Re: City of Palmdale Hybrid Power Plant Project: Docket No. 08-AFC-9

Subject: Response to the June 10, 2009 Comments on the Palmdale Hybrid Power Project's Request for Incidental Take Permit for Mohave Ground Squirrel and Additional Comments Regarding Impacts to Biological Resources, CEC Docket 08-AFC-9

Palmdale Hybrid Power Project
Attachment -- Responses to Comments
08-AFC-9

Palmdale Hybrid Power Project
 Habitat Suitability for Mohave Ground Squirrel
 Overview

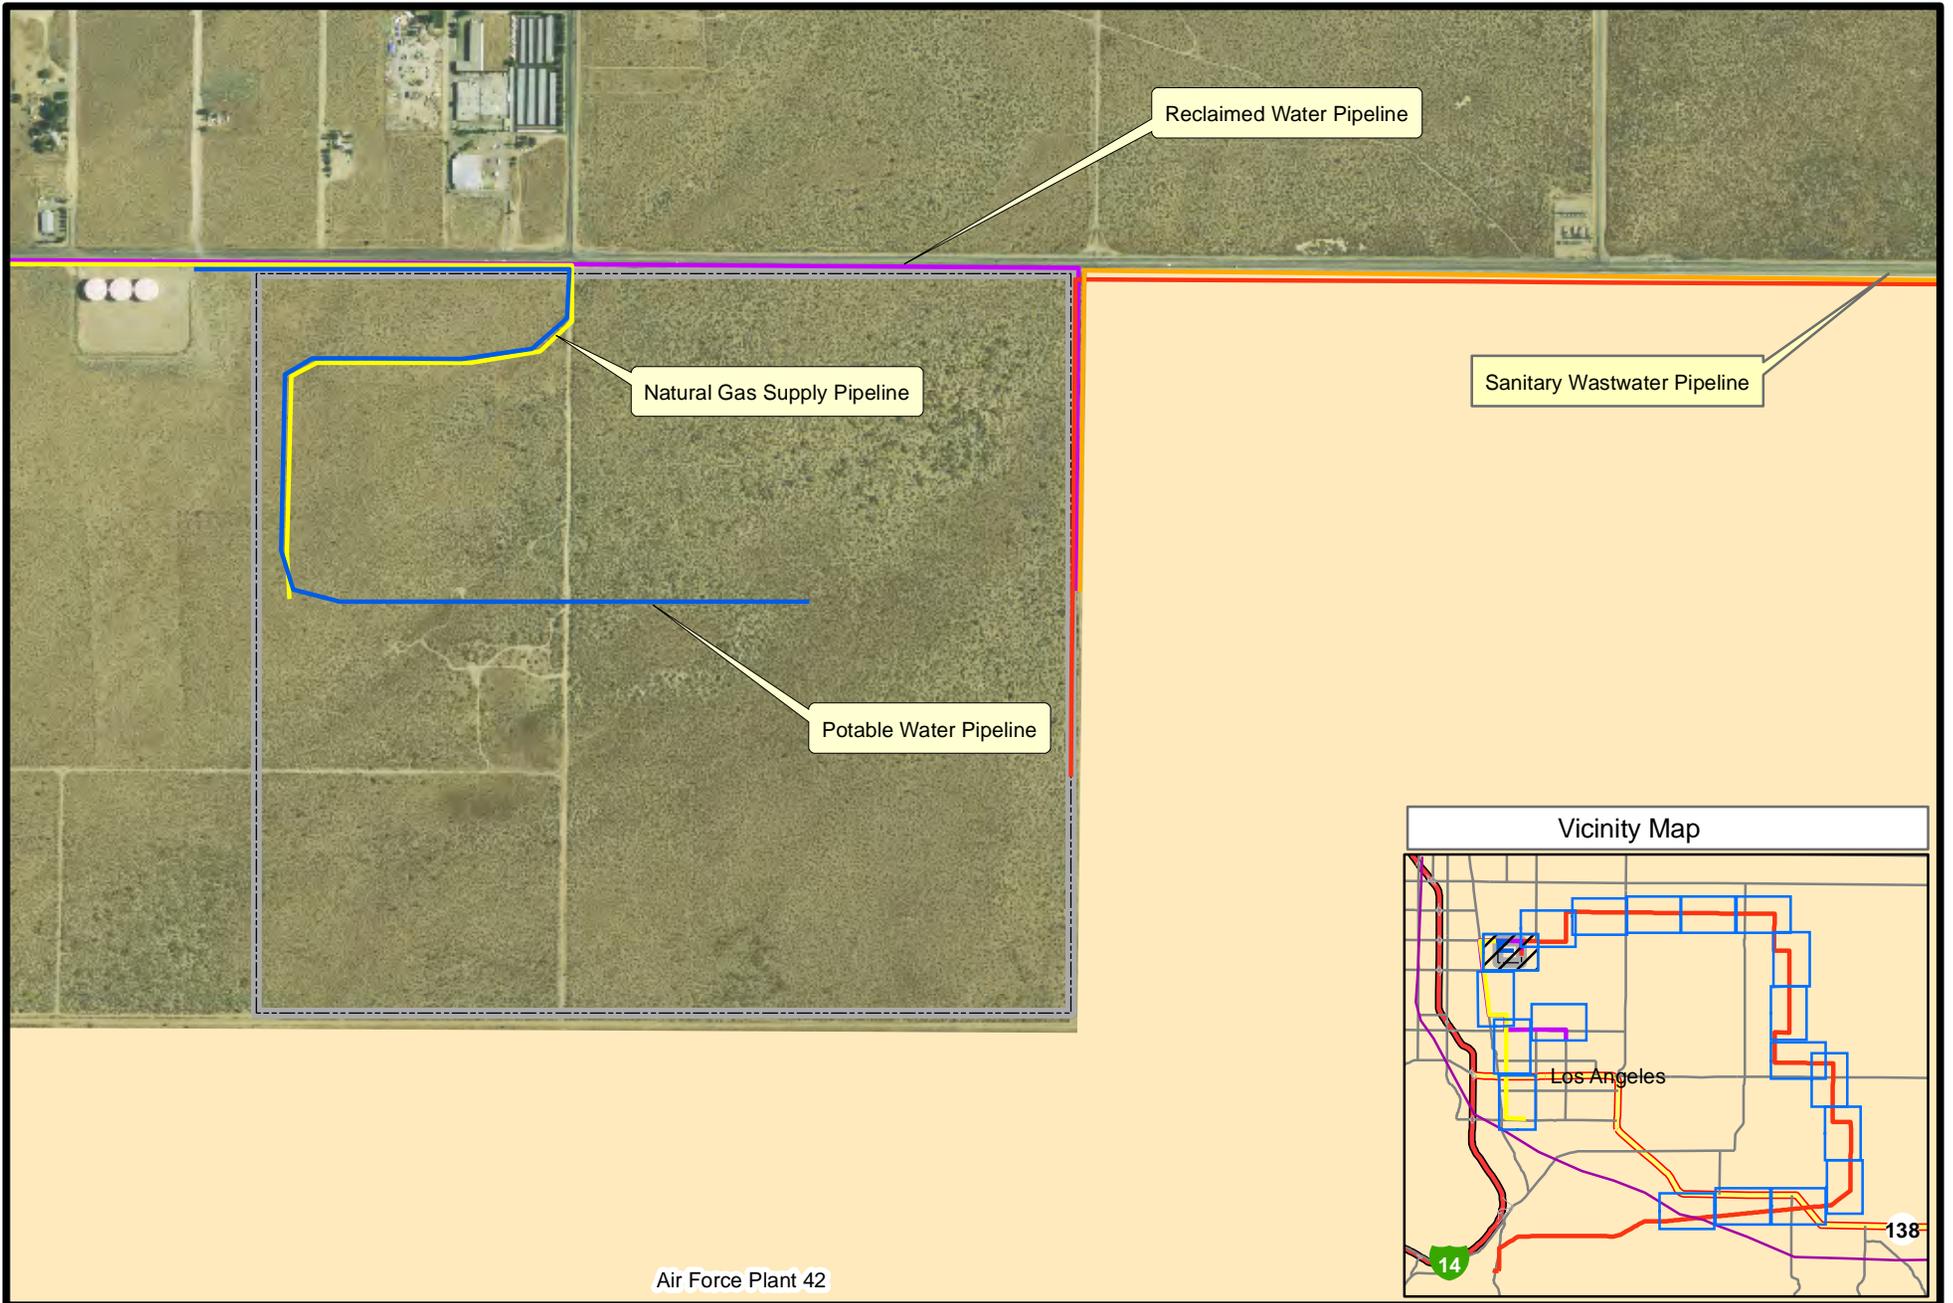
Page 7 of the application states "... of the total 416.11 acres of disturbance (not clear if this includes all transmission line impacts) "approximately 271.64 acres may include vegetation potentially suitable for Mohave ground squirrel (Table 2)." However, Table 2 and in the text on Page 6, states 321.54 acres are identified as suitable habitat for Mohave ground squirrel (*Spermophilus mohavensis*). The applicant should clarify the discrepancy in acres. A more clear identification of total project impacts might clarify this issue. In addition, the Application should include a habitat assessment and map of suitable habitat for Mohave ground squirrel to allow the Department and Commission to evaluate "take".

The correct acreage is 321.54 acres. Therefore, page 7 should state, "Of this acreage, approximately 321.54 acres may include vegetation potentially suitable for Mohave ground squirrel (Table 2)." Phil Leitner, PhD., prepared a habitat assessment and map of suitable habitat for MGS. This document was included in Attachment 2 of Appendix H of the Application for Certification (AFC). Maps at a 1:12,000 scale based on Dr. Leitner's report have been produced and are provided at the end of this Attachment.

Habitat Suitability for Desert Tortoise

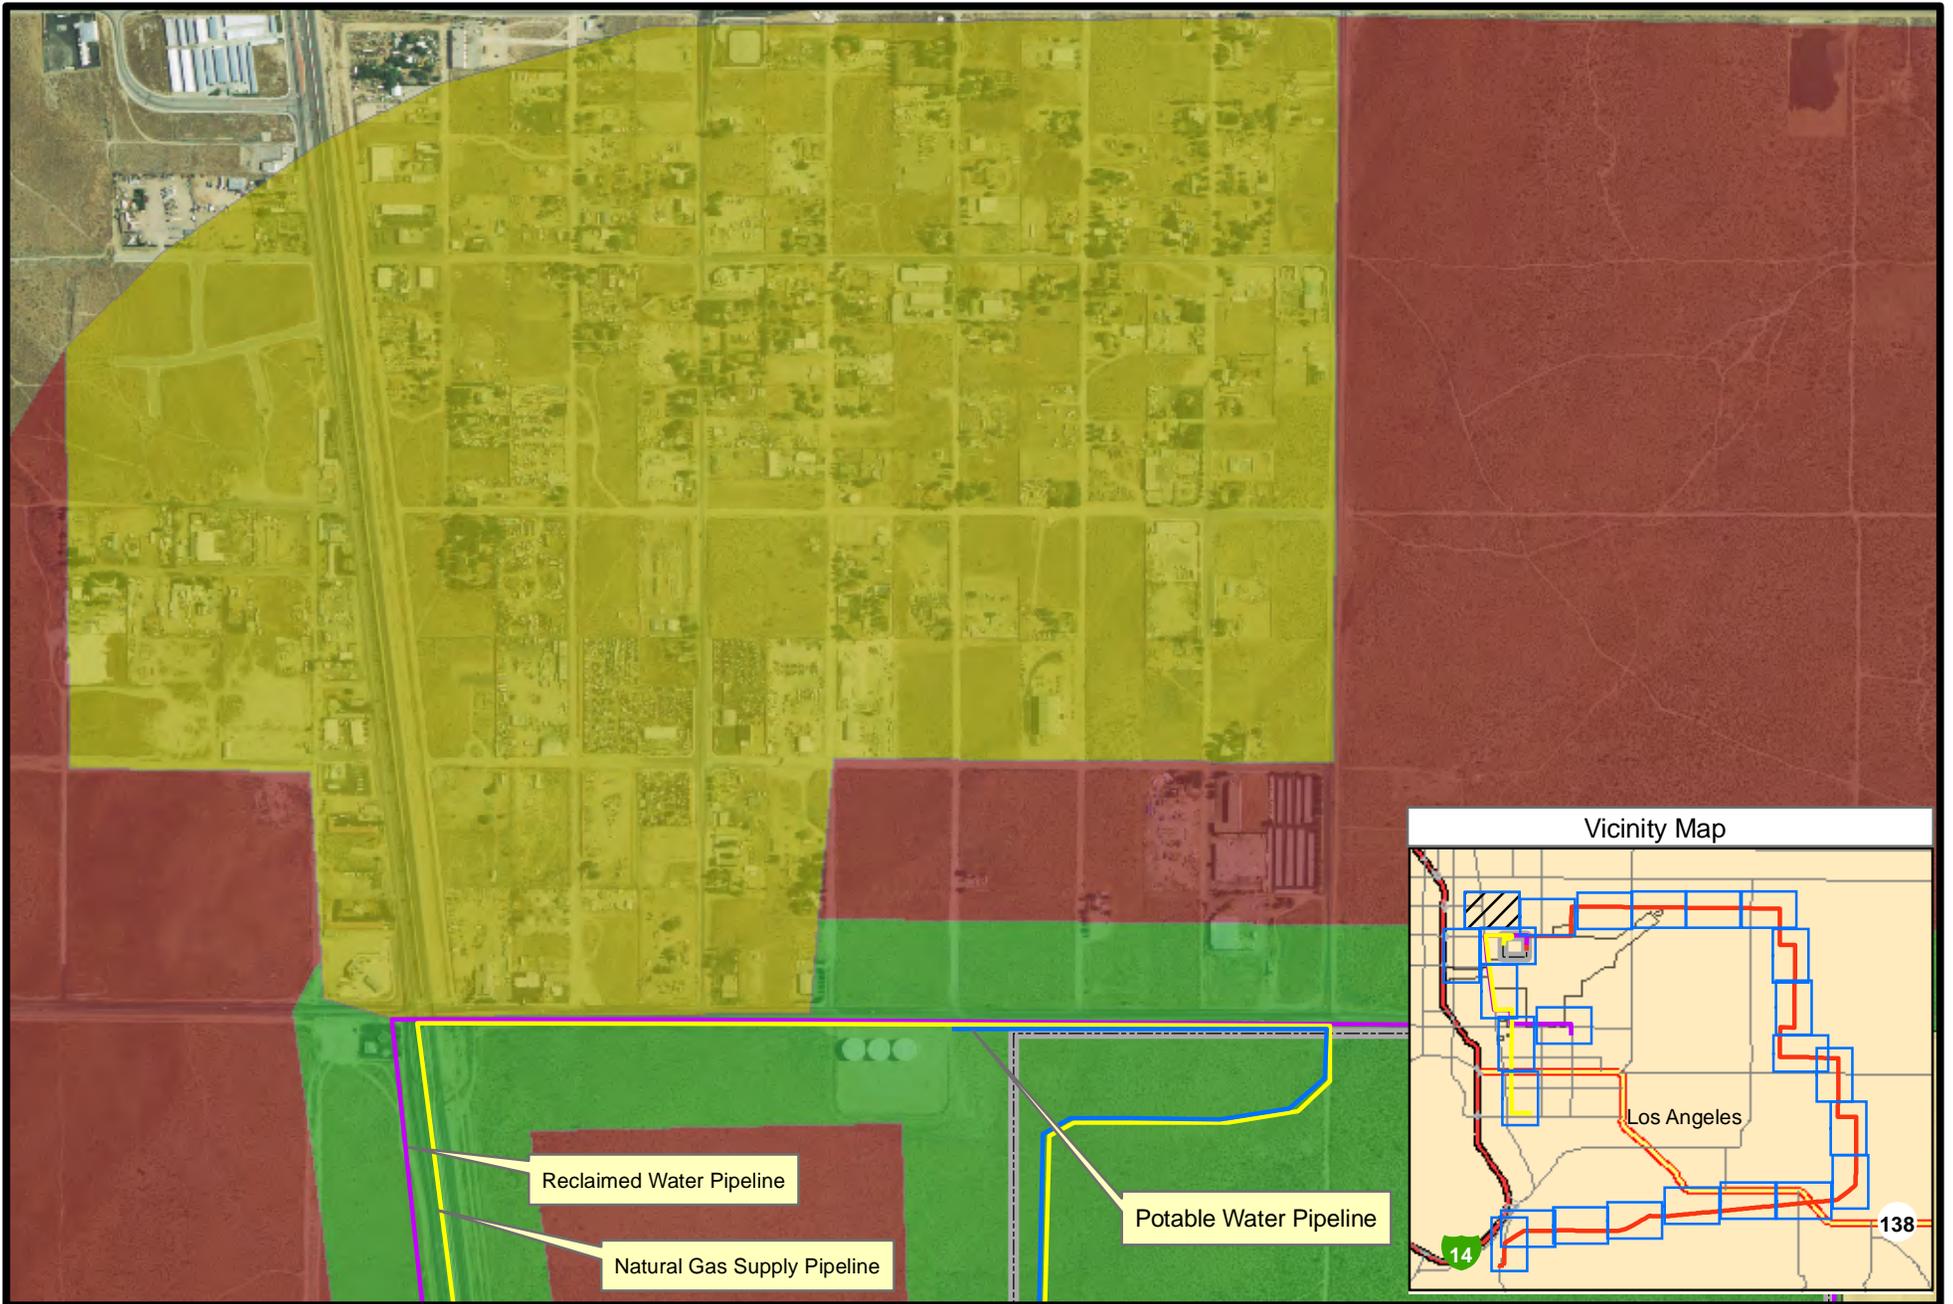
The proposed project is located within suitable desert tortoise (*Gopherus agassazii*) habitat. Desert tortoise surveys were conducted at the power plant site by AMEC in 2006, 2008, and 2009. The transmission lines were surveyed in 2006, with additional surveys along re-alignment sections in 2009. Based on these survey results, and confirmed in a conference call on May 26th, the Department has determined additional desert tortoise protocol surveys would not be required for the project. However, for areas that supported suitable tortoise habitat, construction surveys, restrictive fencing and monitoring would still be required. In addition, any changes in the transmission line alignment would require subsequent protocol level surveys. The applicant agreed to provide the Department with detailed alignment maps delineating all suitable desert tortoise habitat.

Maps at a 1:12,000 scale showing desert tortoise habitat in the surveyed areas have been produced and are provided at the end of this Attachment. Further alignment changes are not anticipated, but should they occur, additional surveys will be conducted in those areas.
